66666 BATTERY RECOMMENDATION MEETING 1.17.2023 | SDCI # 3039257-LU

616 BATTERY STREET

EDG RESPONSE

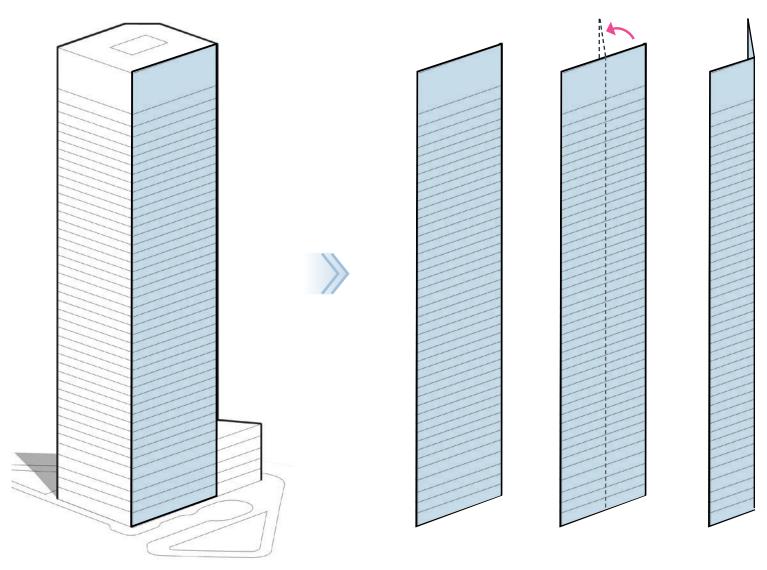
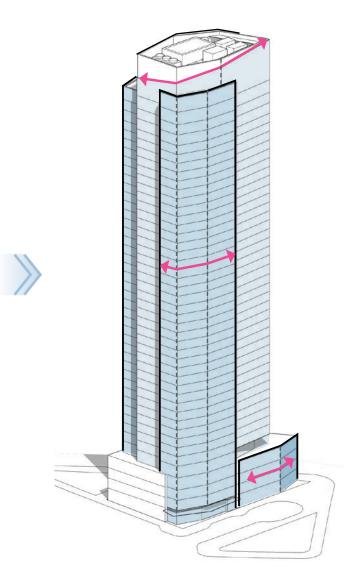
The Board supported the faceted planes of the 'Fold' massing and how they pulled away from the corner of Borealis Avenue and Denny Street, successfully slimming the tower mass when viewed from the north. The Board also appreciated how this move created a visual transition from the curved geometry of 'The Spire' tower to the northwest to the boxier shape of the 'Block V' development directly to the south across Battery St. Moving forward, the Board recommended that the 'Fold' concept be retained and further developed through the articulation of the facades and application of materials to further enhance the architectural concept. (A-1, A-2, B-2.1, B-4.1)

RESPONSE: "BREAK FROM THE BOX"

The Fold concept and massing has been retained and carried further through the architecture. The core concept remains, breaking a traditional rectilinear facade down vertically by creasing and folding the massing, contextually responding to the site and neighborhood while creating a dynamic facade that opens sight lines around the tower and breaks down the visual bulk and scale of the building.

EDG RESPONSES **I.A** Tower Fold Concept (CONTINUED)

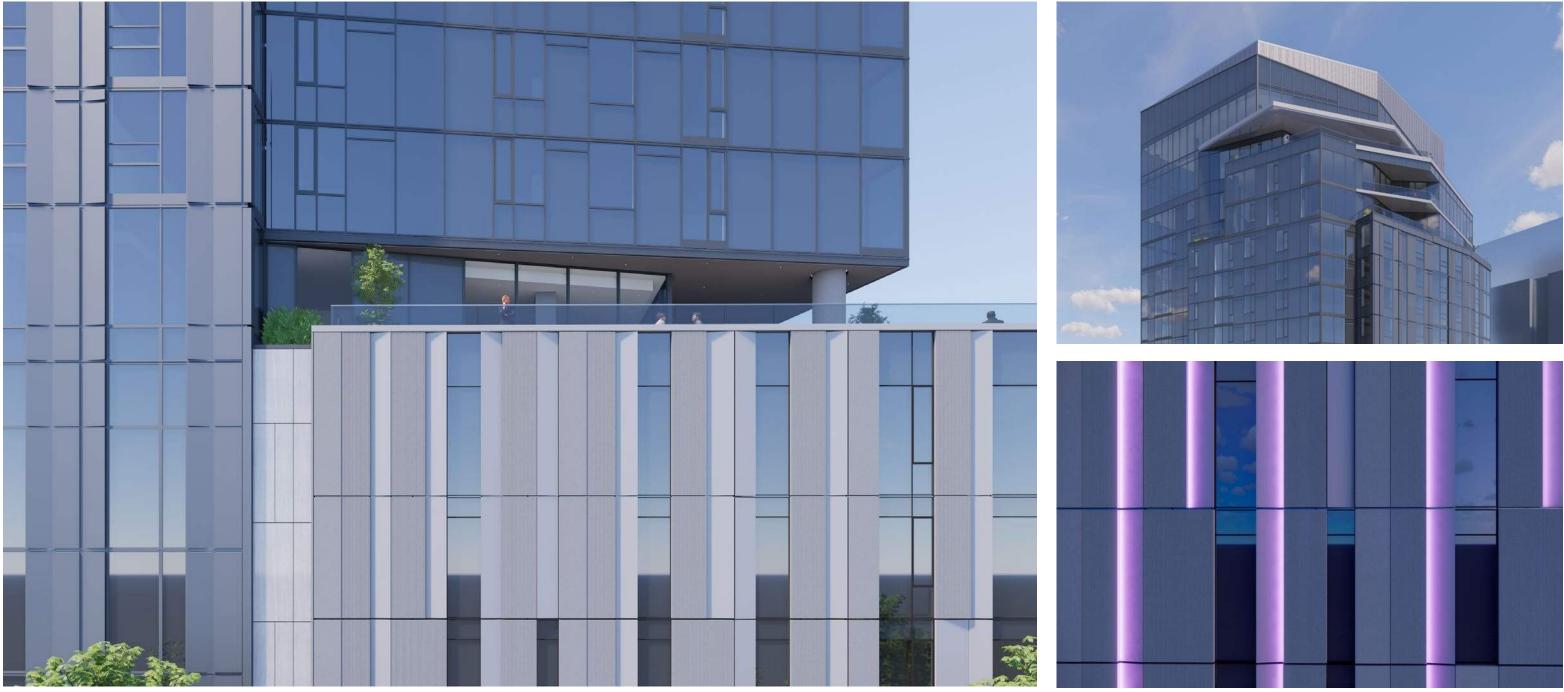
The Board supported the faceted planes of the 'Fold' massing and how they pulled away from the corner of Borealis Avenue and Denny Street, successfully slimming the tower mass when viewed from the north. The Board also appreciated how this move created a visual transition from the curved geometry of 'The Spire' tower to the northwest to the boxier shape of the 'Block V' development directly to the south across Battery St. Moving forward, the Board recommended that the 'Fold' concept be retained and further developed through the articulation of the facades and application of materials to further enhance the architectural concept. (A-1, A-2, B-2.1, B-4.1)

RESPONSE: "FOLDS AT MANY SCALES"

The Fold concept has also been carried through all aspects of the facade treatment from the podium to the mechanical screen. Folded panels create the solid treatments across the podium facade and solid panels in the tower, and are utilized again in the mechanical screen, canopy profile, and even the form liners for the concrete along the alley.

EDG RESPONSES **I.B** Rooftop Form

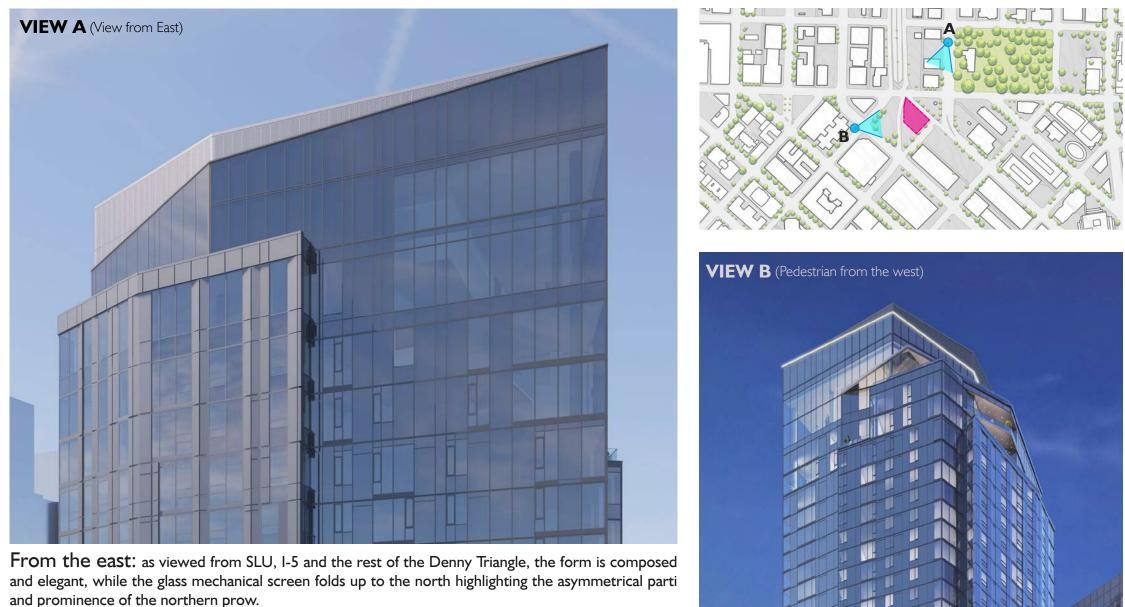
The Board noted that the shape and modulation of the tower top was of particular importance for this project based on the site's position in the city and its visibility from many directions. The Board had concerns that the design of the upper portion of the building did little to promote visual interest and variety in the downtown skyline and that the upper-level decks appeared arbitrary and unrelated to the 'Fold' concept. Moving forward, the Board recommended that the applicant continue to study the design of the upper portions of the building to further reinforce the architectural concept while providing a more sculpted terminus to the central mass. (A-2.1, B4.1)

RESPONSE: "STEP AND FOLD"

The rooftop and penthouse deck design has been re-imagined to both create a unique and identifiable element in the skyline that differs from surrounding projects, and that better implements the 'Fold' concept into the overall massing. The previous design at EDG was a simple vertical extrusion of the floorplate, terminating at the zoning and rooftop height. Now, the decks and upper levels themselves become folded elements that terrace and step the upper forms of the tower, and the rooftop canopy becomes one more move in this dynamic layered concept. The mechanical screen itself furthers that motion, folding horizontally to express the dynamic and asymmetrical nature of the design and the prominence of the northern corner. When viewed from below and the surrounding city, those elements tie together in creating a unique top that step and folds to reduce the bulk and scale of the crown and create an identifiable element, better meeting the goals of guidelines A.2.c. s

EDG RESPONSES I.C Tower and Podium Integration

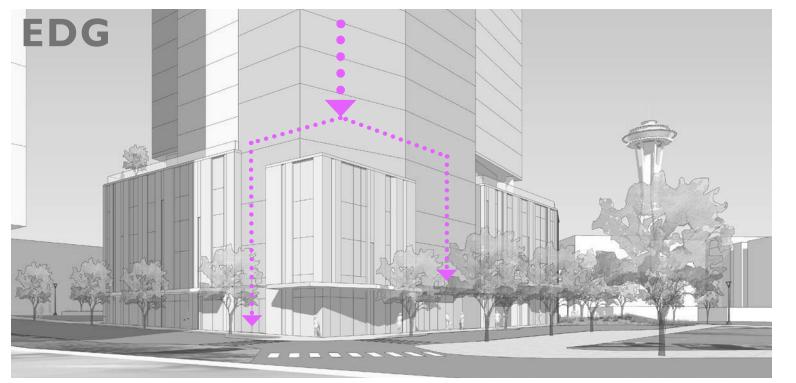
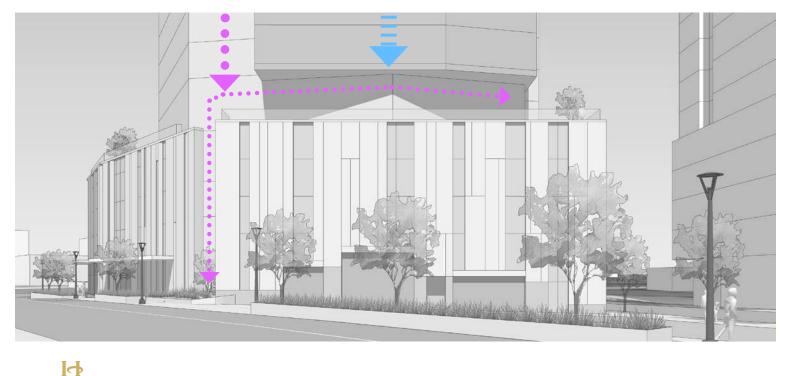
The Board appreciated the overall design of the podium levels of the building and strongly supported how the tower portion of building was brought down to grade on the 7th Avenue side, successfully integrating the two portions of the building together. Moving forward, <u>the Board recommended that the applicant study ways to incorporate similar intermixing of the tower</u> and podium on the Battery St. Borealis Ave. and alley sides of the building. (B-2.3, B-3.2, B-4.1)

7th and Battery Corner at EDG. The small podium "attachment" at the corner was disconnected, busy, and broke up the larger verticality in the facade and removed the ability to increase area for the public at grade. Along the alley, the tower floated above the podium and was only expressed to grade at one narrow point on the corner.

As the team studied how to better connect the tower to grade and increase the pedestrian realm, it became clear the small detached podium element at the corner was an encumbrance to the design and inconsistent with the Board's guidance to bring the tower to grade. Removing that element opened up grade, views around the project, wayfinding to the main building entry, and allowed additional space for landscaping, seating, and pedestrian circulation. Through studies of the neighbors' plans we found it also mimicked the shaping of nearby projects as shown on page 24. Similar to the west facade, the alley and corner on Borealis now both extend down into the podium. At the corner on Borealis the tower expression that comes to grade has been enlarged, and the central tower mass now extends all the way down to SPU's 26' clearance.

EDG RESPONSES **I.D** Podium Design

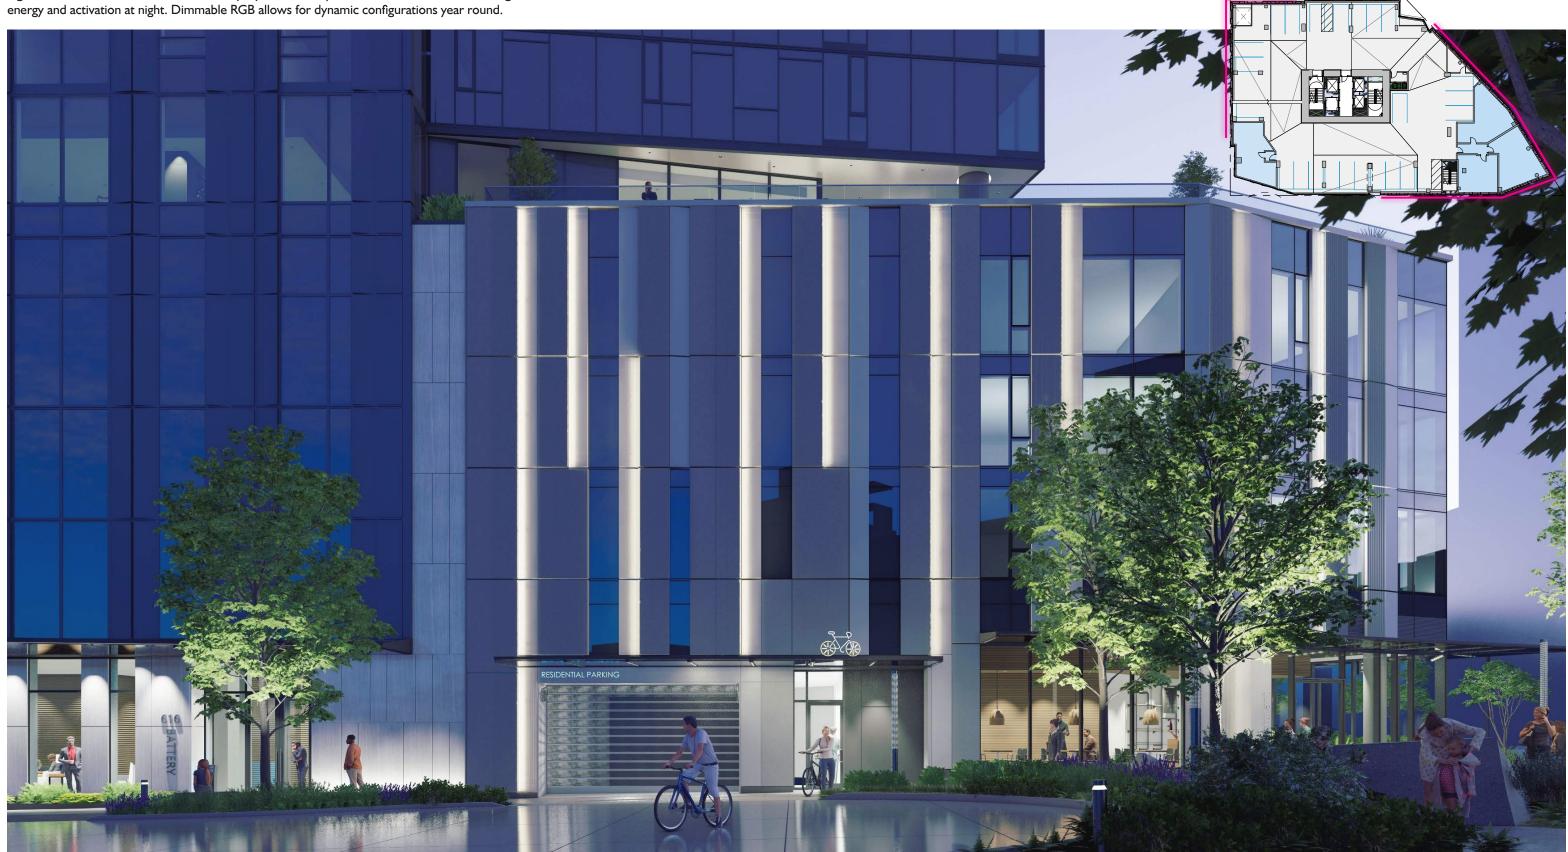
The Board appreciated the articulation of the building's podium with the smaller scaled faceted facades, which reference the larger architectural massing concept of the tower above. The Board also highlighted the subtle differences between storefront fenestration into residential units and spandrel/louvers that blur the visibility of the above-grade parking and not drawing attention to itself. The Board recommended that this blurring of uses behind the facades of the podium be retained moving forward. (B-4.2, C-2.1, C-3.1, E-2.1)

RESPONSE: "SEAMLESS SCREEN"

The podium design and screening solutions shown at EDG have been expanded to include the tower skin and blending of the two systems into a seamless skin system. Activation day and night through transparency, lighting and textured materials creates an elegant podium design that makes the parking program completely invisible to the public.

EDG RESPONSES 2.D Entry Locations (CONTINUED)

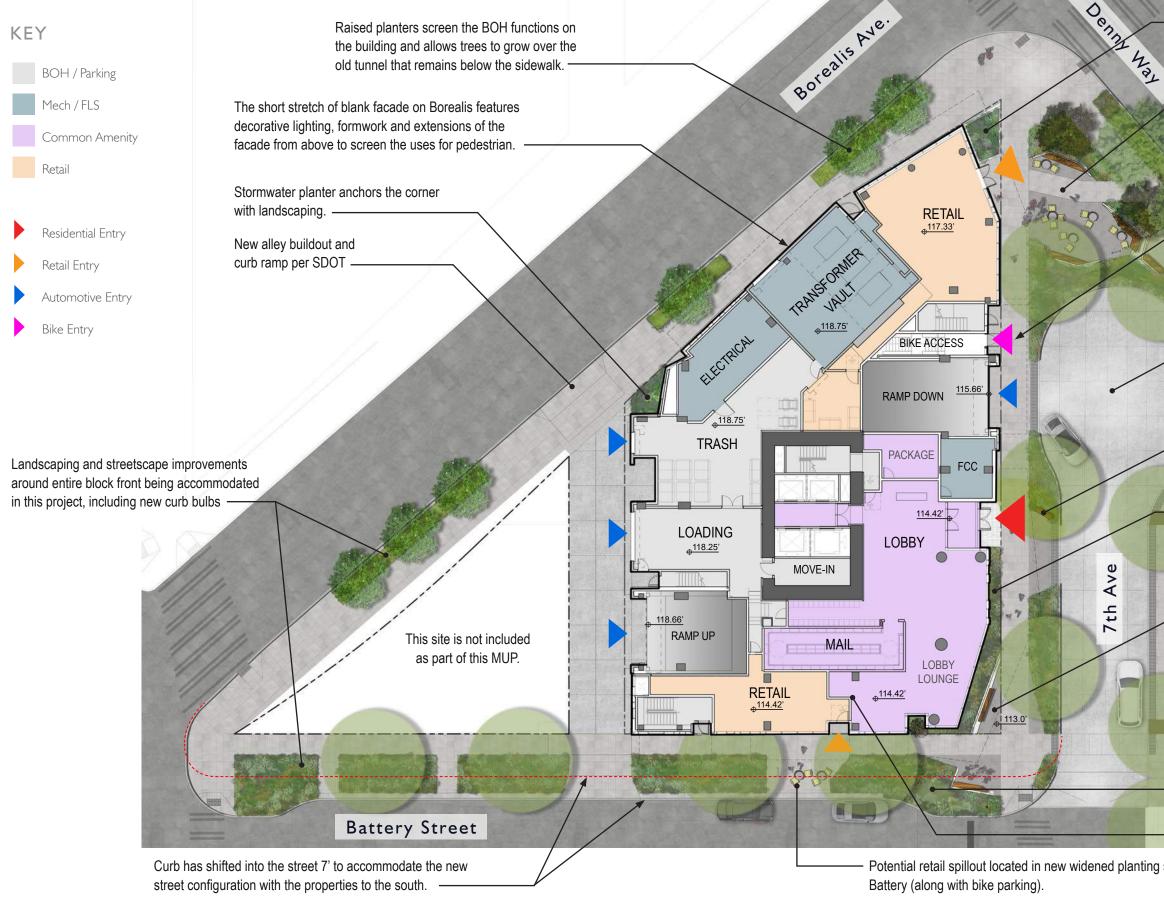
The Board supported the location of the main residential entry on 7th Ave and appreciated its integration into the tower mass that was brought to the ground in this location. The Board recommended that all of the entries to the building should be differentiated and easily identifiable. (C-4)

The secondary entires to the building are unified through canopy details and expressions, but each have their own character that relates to the spaces it connects. The northern retail space is defined by the folded geometry that creates additional open space. The retail space on Battery utilizes the same canopy detailing, with a recessed entry and a signage band above the space. The bike entry features its own stepped canopy that ties the major transportation entries together, and will feature a glass entry and LED signage. Because the bike room is only for residents and not the public, the hierarchy and visual cues were reduced from the other entry points.
